REQUEST FOR TENDERS ADDENDUM

Addendum Number: Two (2)	Date: June 9, 2022	Pages: 4
Reference Number: 2022-0024 - SC	Project Title: Washroom Retrofit	Date RFT Issued: May 24, 2022

BID DOCUMENTS FOR
WSCC GENDER NEUTRAL WASHROOMS

GENDER NEUTRAL WASHROOMS

Title
SCHEDULES AND DETAILS

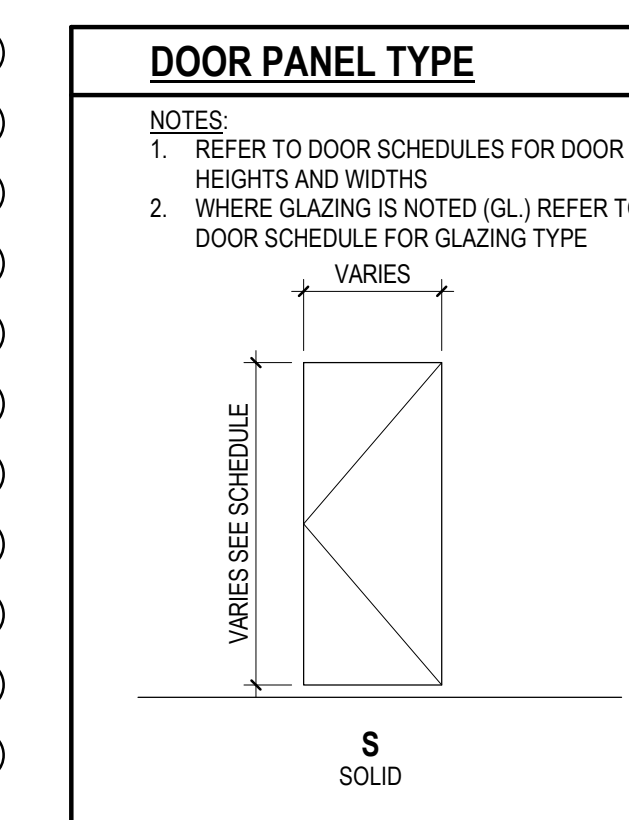
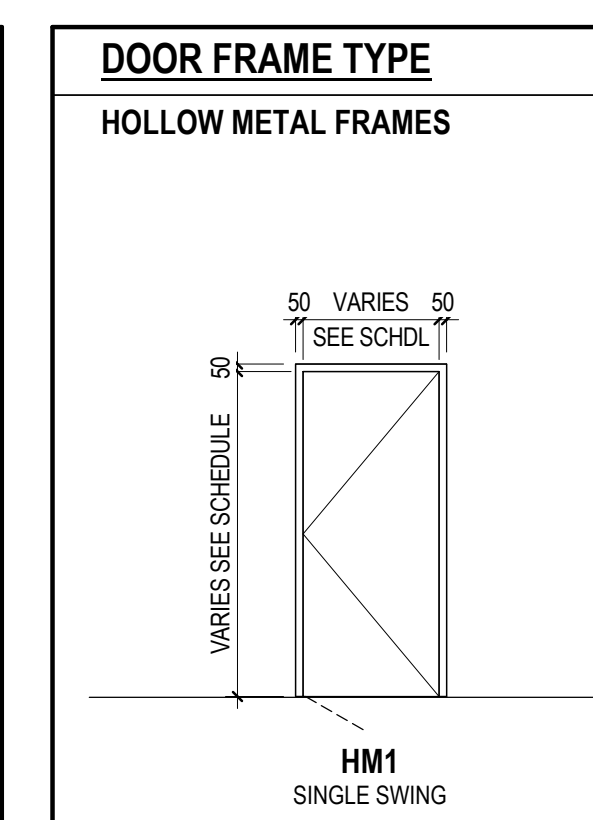
3.1. A-600 – Schedule and Details

The door schedule has been amended to include doors E501 and E502.
